### HISTORIC AND DESIGN REVIEW COMMISSION

**HDRC CASE NO:** 2022-486

**ADDRESS:** 209 W POPLAR ST

**TYPE OF WORK:** Front porch enclosure **APPLICATION RECEIVED:** September 16, 2022

SECOND LEVEL FLOOR PLAN - PORCH ENCLOSURE

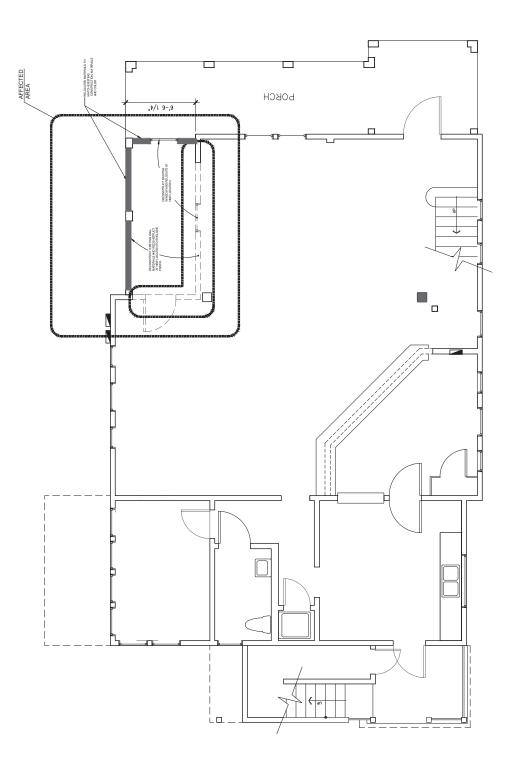
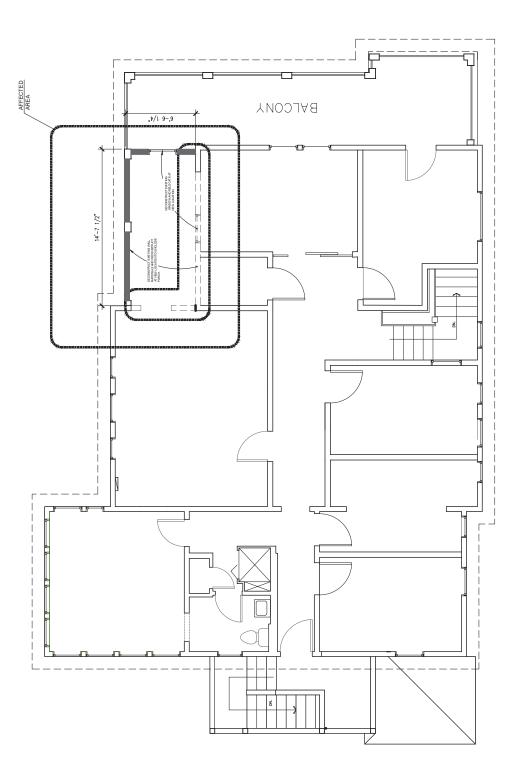
- c. PORCH ENCLOSURE The applicant has proposed to deconstruct the existing east elevation and reuse the existing siding and windows to enclose the 2-story side porch. The existing 2-story front porch is original to the structure in its existing configuration. The applicant has proposed to retain the vertical trim piece and slightly inset the side porch enclosure from the front façade. The applicant has expressed that the porch enclosure is designed for reversibility and could be easily removed in the future. Guideline 7.B.i for Exterior Maintenance and Alterations states that applicants should refrain from enclosing front porches. Additionally, Guideline 7.B.v for Exterior Maintenance and Alterations recommends that porches are reconstructed based on accurate evidence of the original, such as photographs. The 1904 Sanborn Map shows that the existing footprint of the front façade and front porch is original to the structure. Staff finds the proposal inconsistent with the Guidelines.

Staff does not recommend approval of enclosing the front porch and constructing a front façade addition based on findings a through c.

- i. That the existing siding and windows are salvaged and re-used in the porch enclosure and the existing doors and transom window are salvaged and stored on site for future use based on finding c.

- ii. That any new windows installed are fully wood to match existing and feature an inset of two (2) inches within facades and should feature profiles that are found historically within the immediate vicinity. Meeting rails must be no taller than 1.25" and stiles no wider than 2.25". White manufacturer's color is not allowed, and color selection must be presented to staff. There should be a minimum of two inches in depth between the front face of the window trim and the front face of the top window sash. This must be accomplished by recessing the window sufficiently within the opening or with the installation of additional window trim to add thickness. Window trim must feature traditional dimensions and architecturally appropriate sill detail. Window track components must be painted to match the window trim or concealed by a wood window screen set within the opening. Faux divided lites are not permitted. The applicant is required to submit final window specifications and updated elevation drawings showing the placement of all proposed windows on the enclosed porch to staff for review and approval prior to the issuance of a Certificate of Appropriateness.
